**Project:** Mertarvik Phase I Power System:  
Power Plant Module

**Solicitation No.:** 18045

**Addendum No. Three**

SHEET TITLE: CONNEX DETAILS  
 SHEET: S3.01  
 DRAWN BY: KJK  
 CHECKED BY: DGT  
 DATE: 02/12/18  
 SCALE: AS SHOWN  
 JOB NUMBER: 16-035

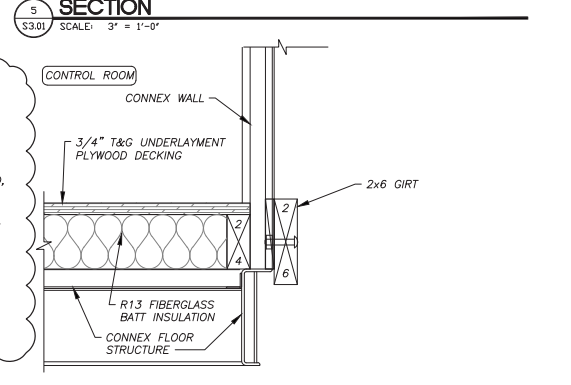
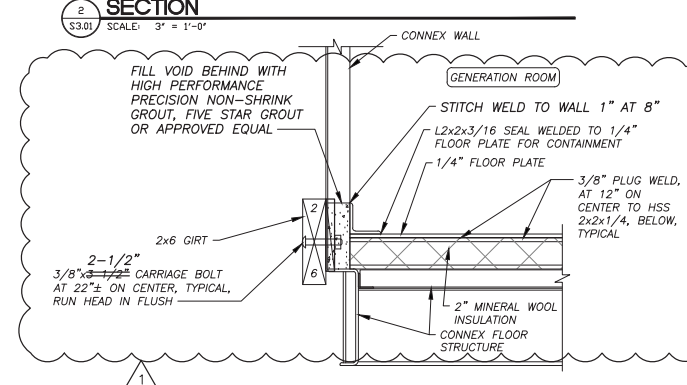
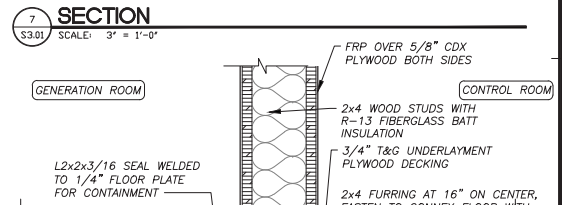
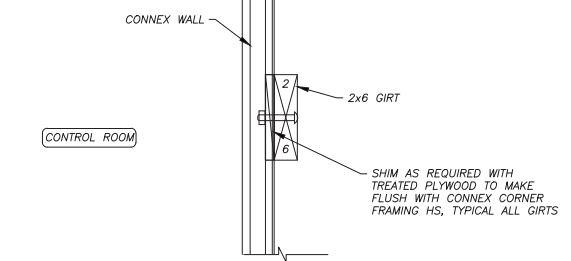
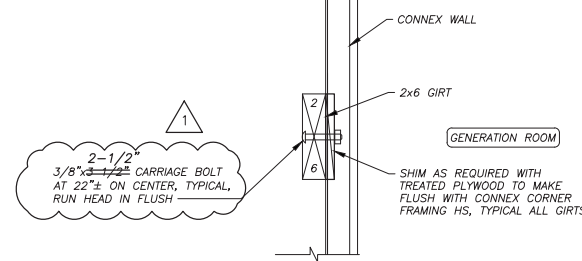
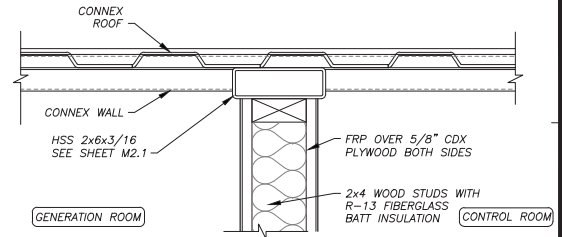
- 5) **Q:** The floor in the control room: Can stainless angle iron and 1" fasteners be substituted for the 5" fasteners to hold the floor joists down to the connex floor?  
**A:** No, attach 2 x 4 furring as shown in Detail 8 Sheet 3.01. (**Attachment A**)

6) **Q:** What is going to be used to fill the voids between the floor and the outer connex wall corrugations or will these spaces be left open?

**A:** Fill voids between the floor and the outer connex wall corrugations with non-shrink grout see revised sheet S3.01 Detail 3 (**Attachment A**). Provide Five Star High Performance Precision Non-Shrink Grout or approve equal. Also note on revised sheet S3.01, In Details 1, 2, and 3 the length of the 3/8" carriage bolts have been changed from 3.5" to 2.5" to allow the ends of the bolts to stay within the corrugations on the inside of the connex interior walls
